RE: Adequacy Questions 2, DRMS AM-4 application – Home Office Mine, Permit M1977-439

RE: Adequacy Review 2 follow-up, DRMS AM-4 application – Home Office Mine, Permit M1977-439

EXHIBIT G: WATER INFORMATION

Enclosures: Figure A: Pre-Mining Groundwater Contours
 Figure B: Dewatering Groundwater Contours
 Figure C: Lined Reservoir Groundwater Contours

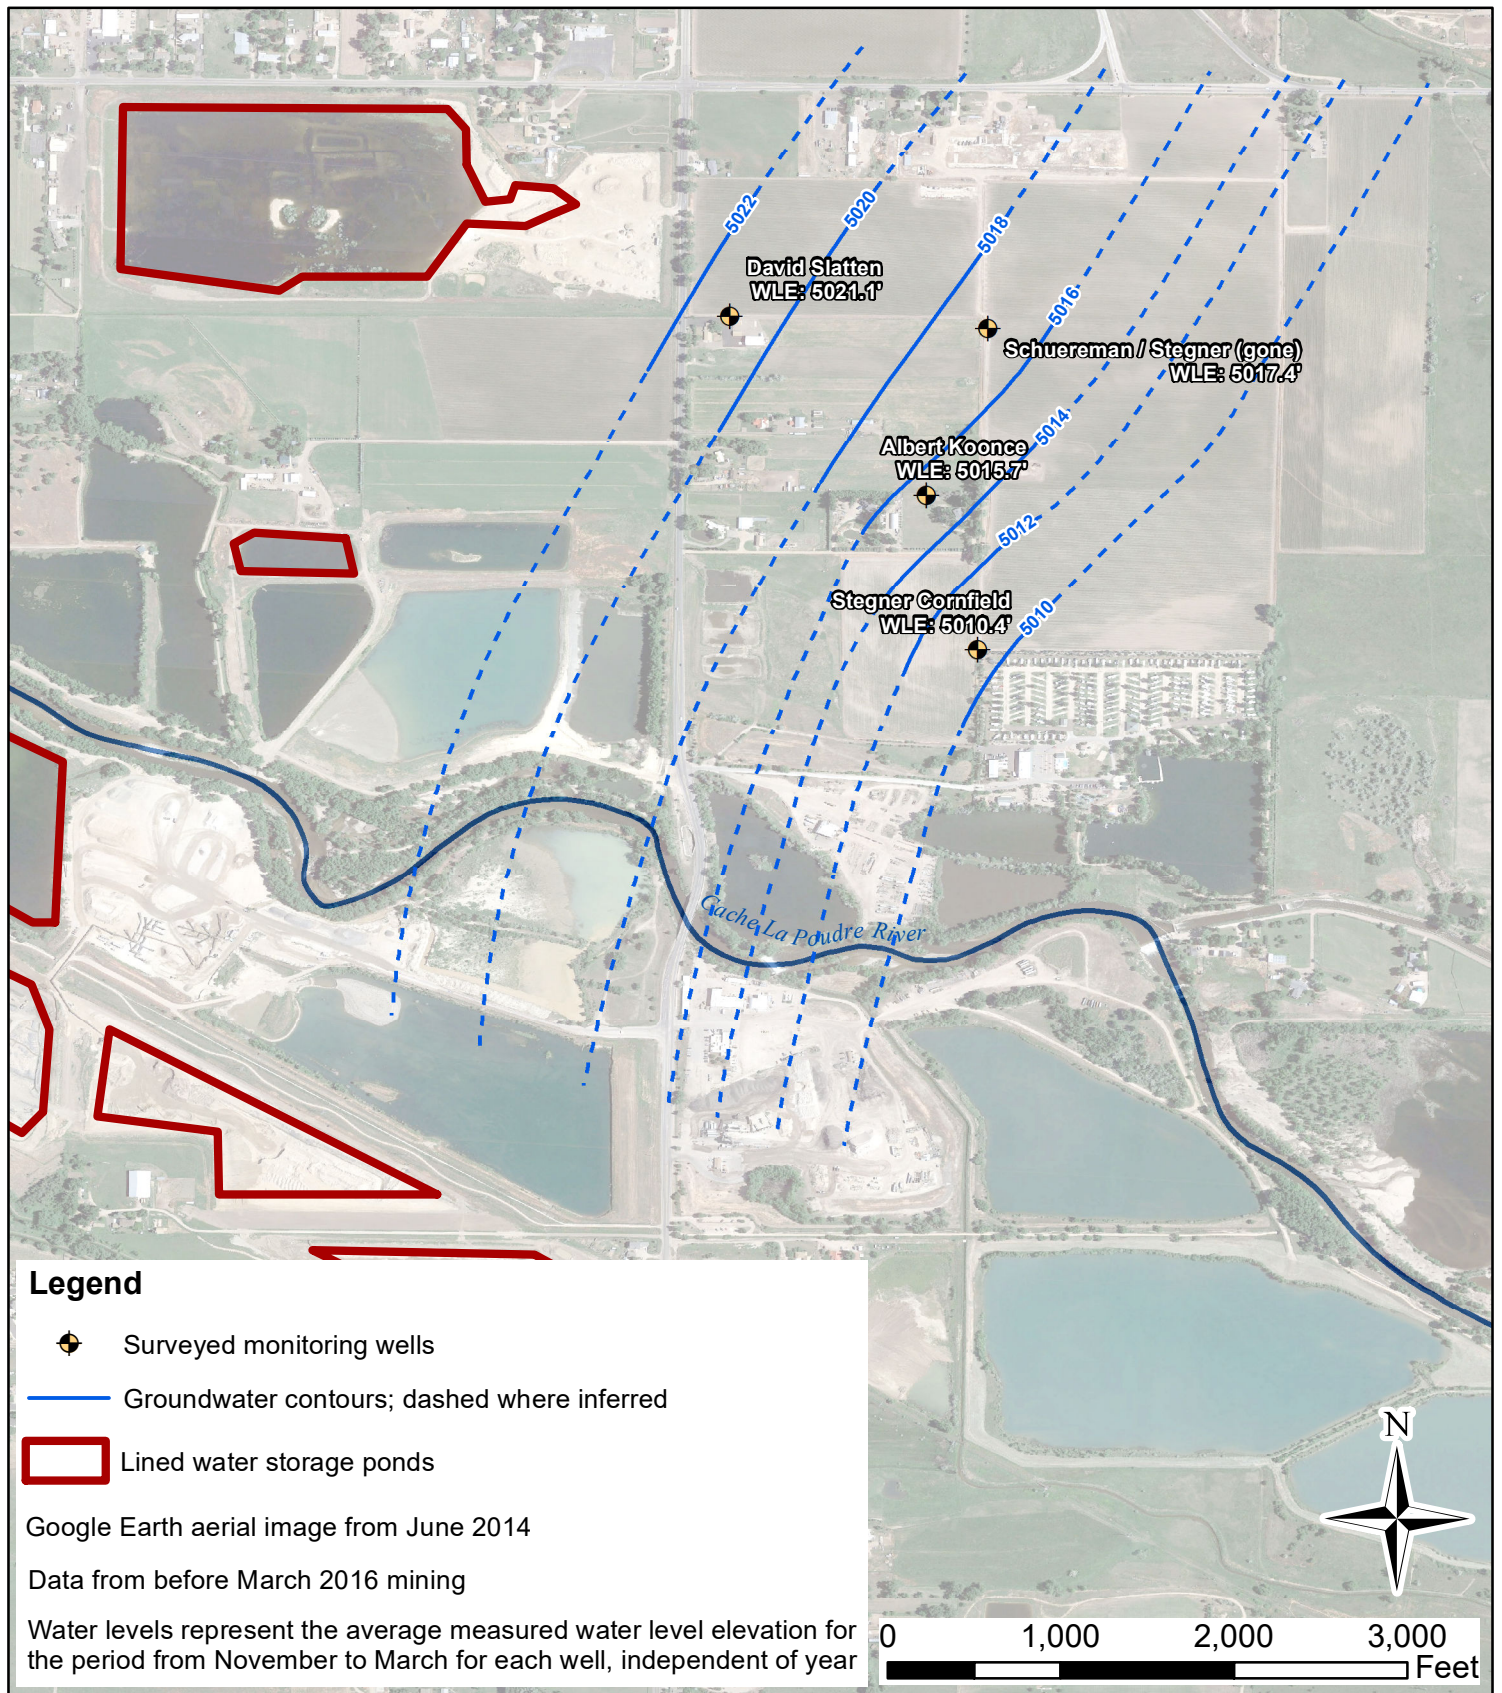
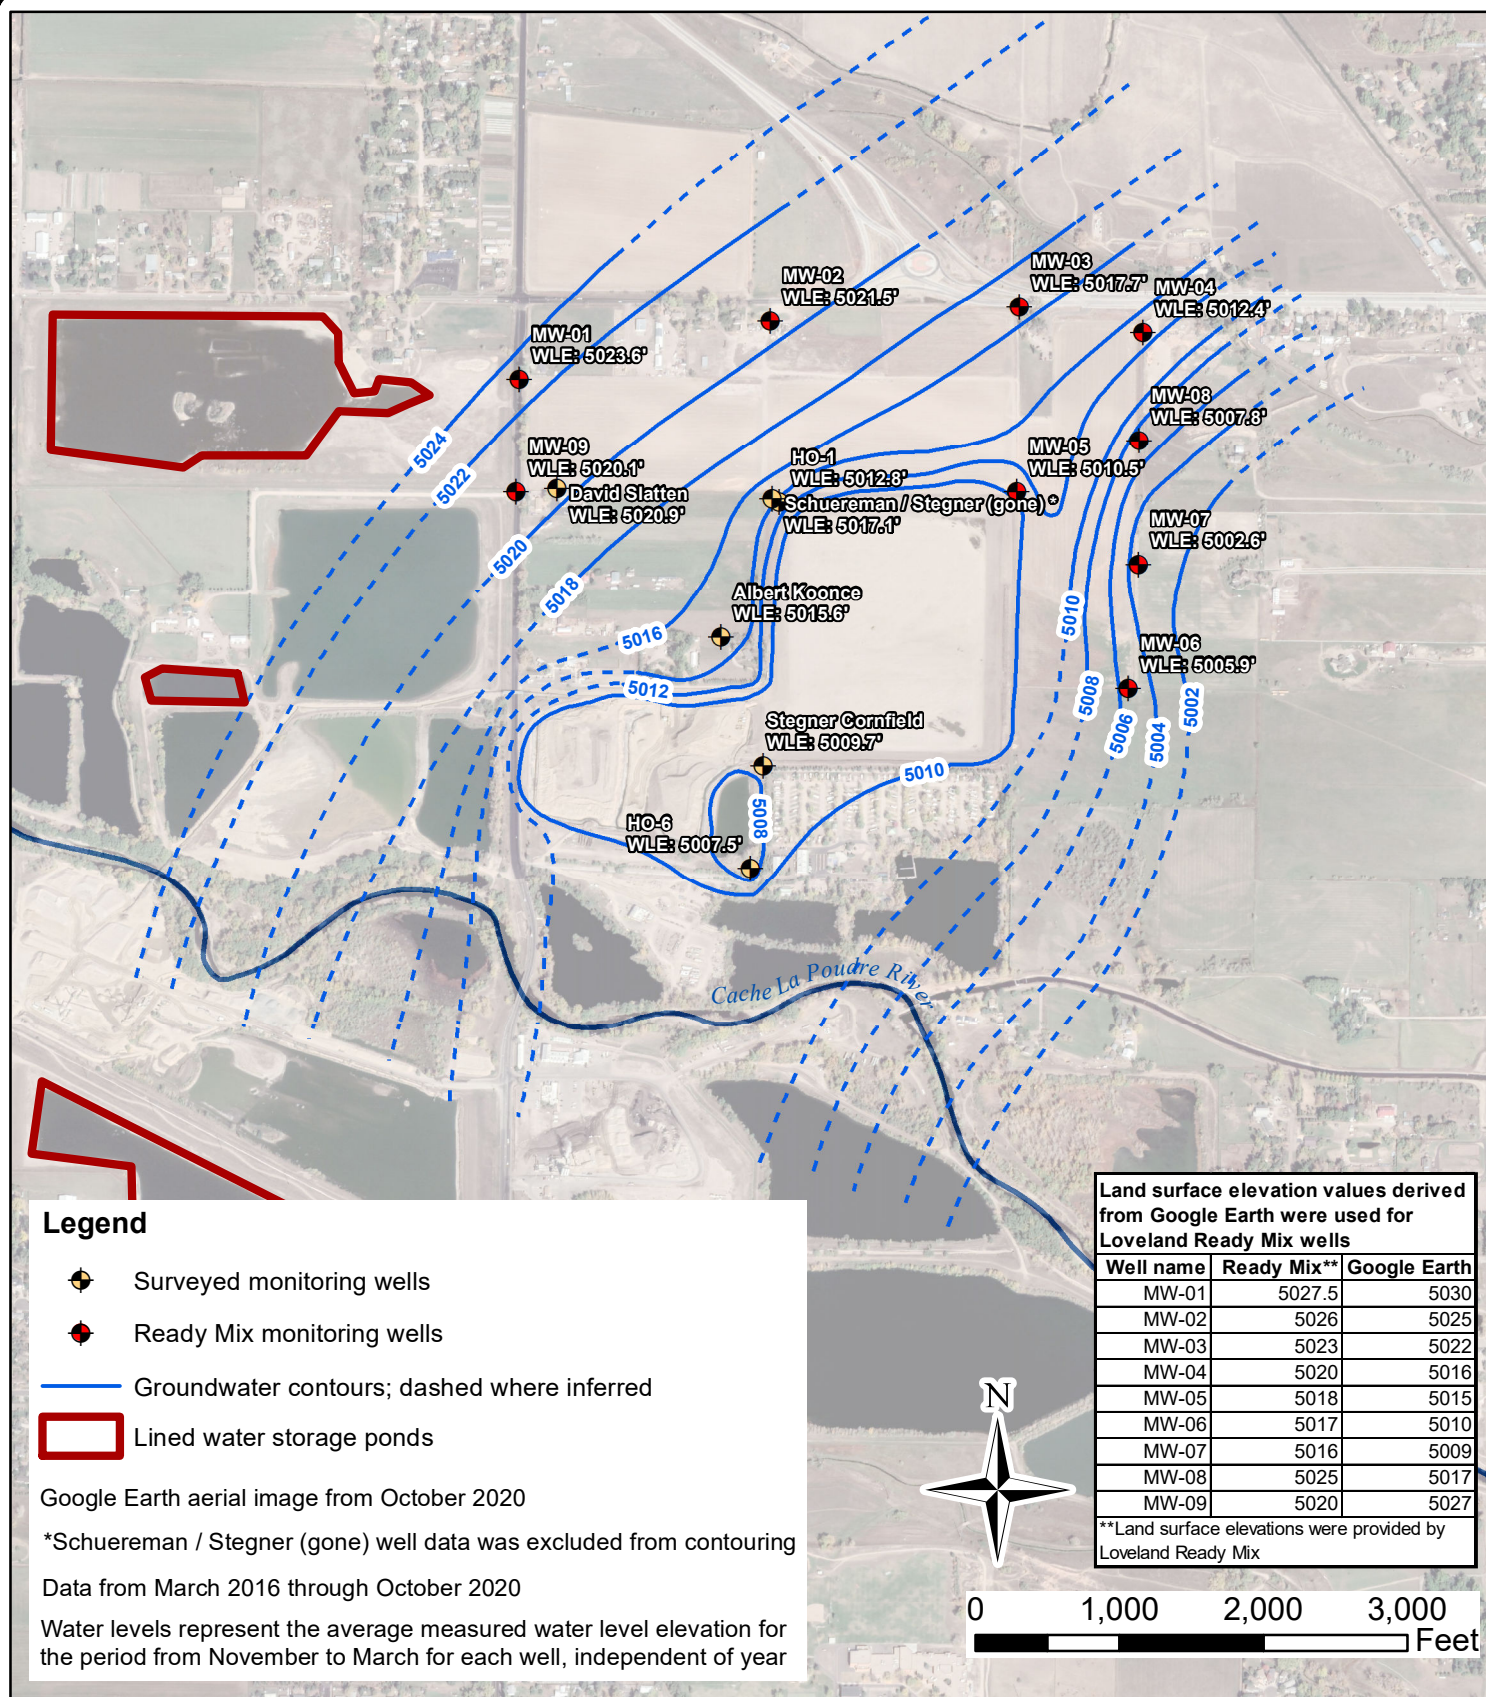
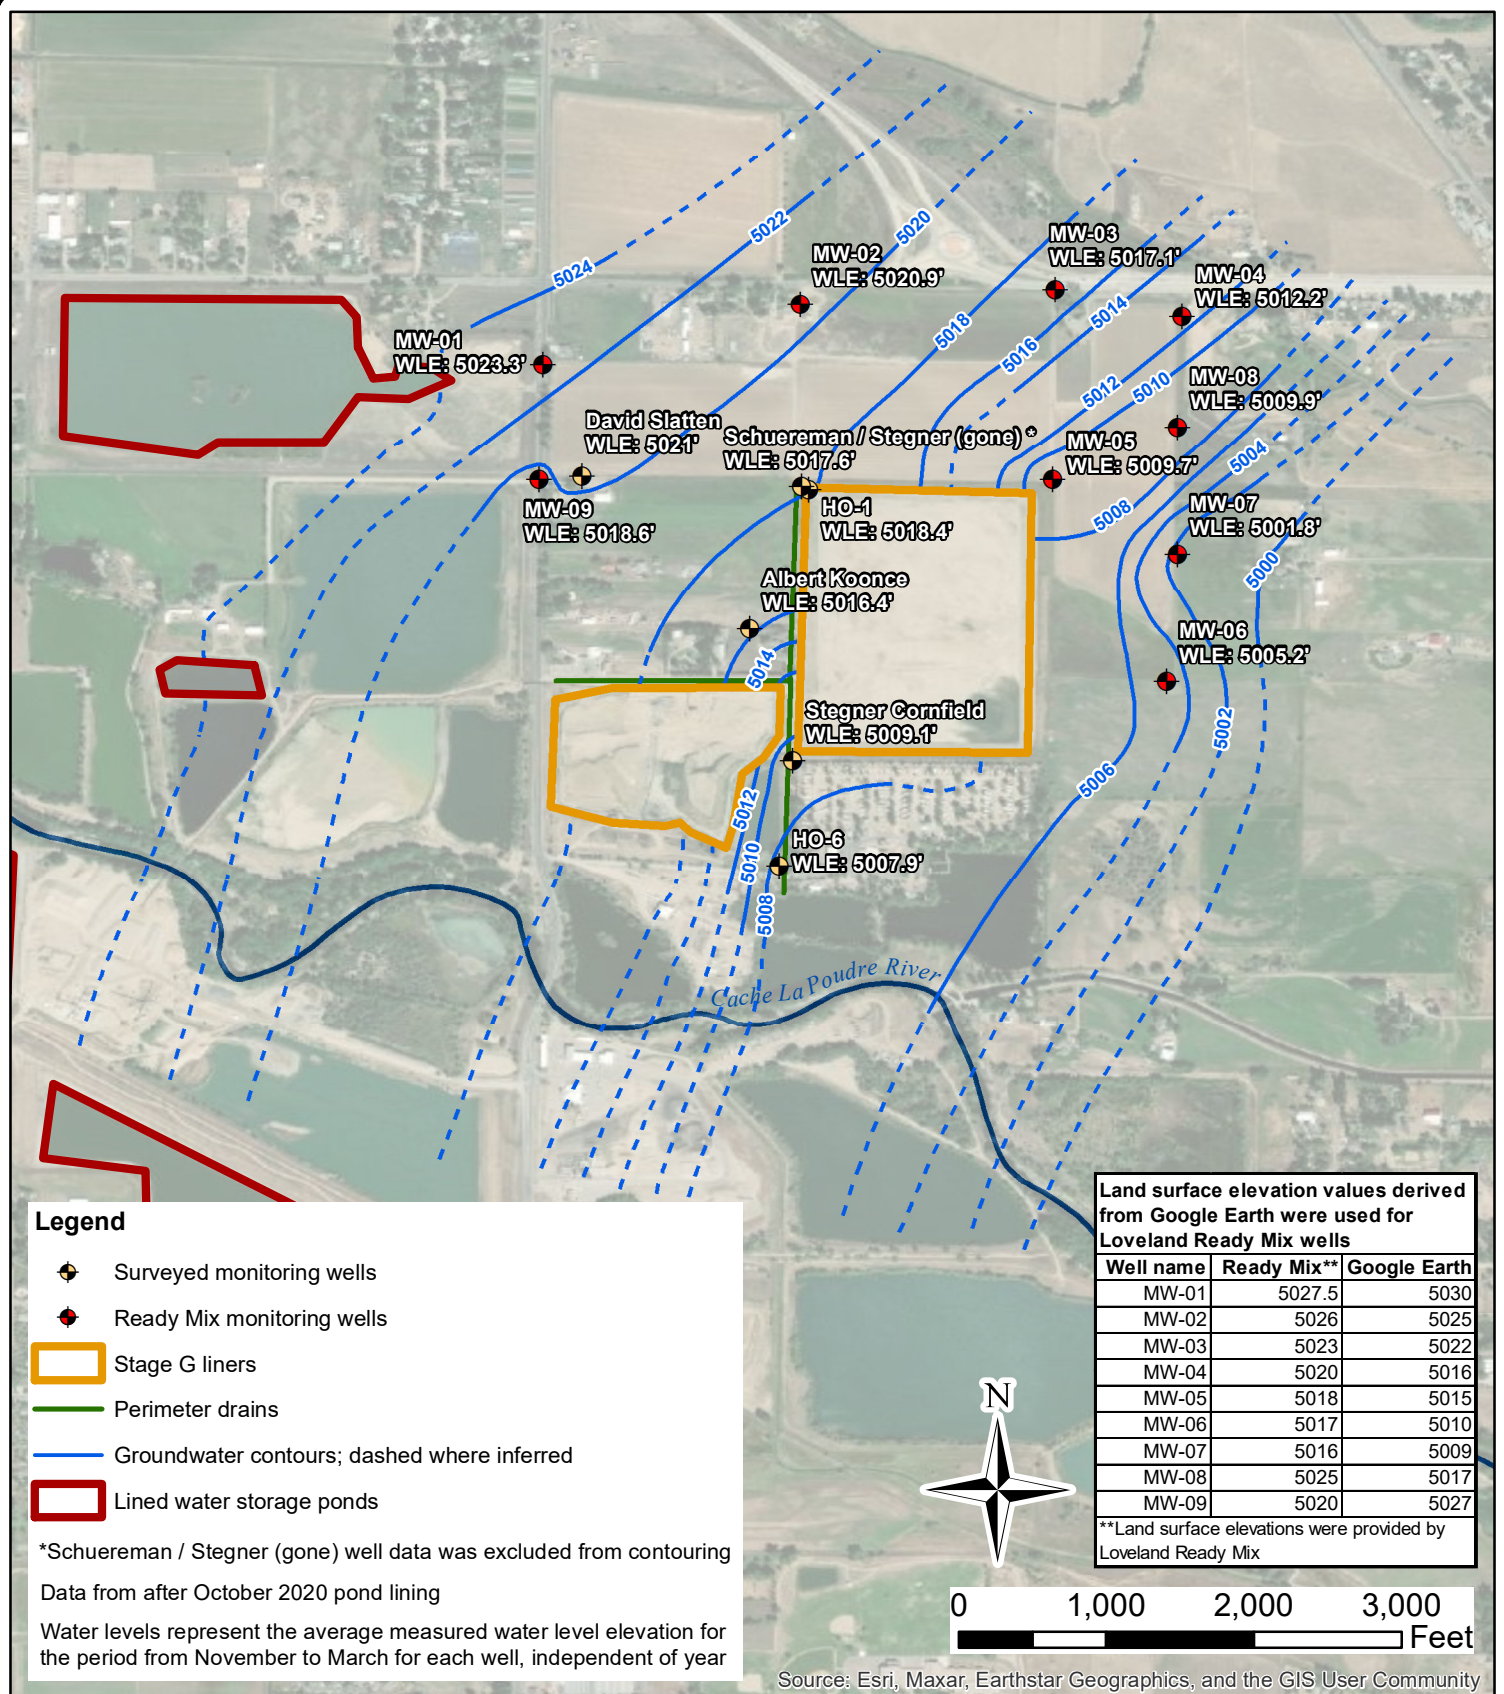
- c. Presentation of historic groundwater level data in the form of GW contour maps to show, where possible, historic GW flow directions and levels/depth below ground surface, along with impacts to the historic patterns due to mining and reclamation. These should place an emphasis on current data to demonstrate minimization of mounding and shadowing impacts.

Tetra Tech has prepared water level contour maps for the area adjacent to the Phase G pits to characterize the general conditions for: pre-mining, dewatered, and the lined reservoir. The three figures are attached.
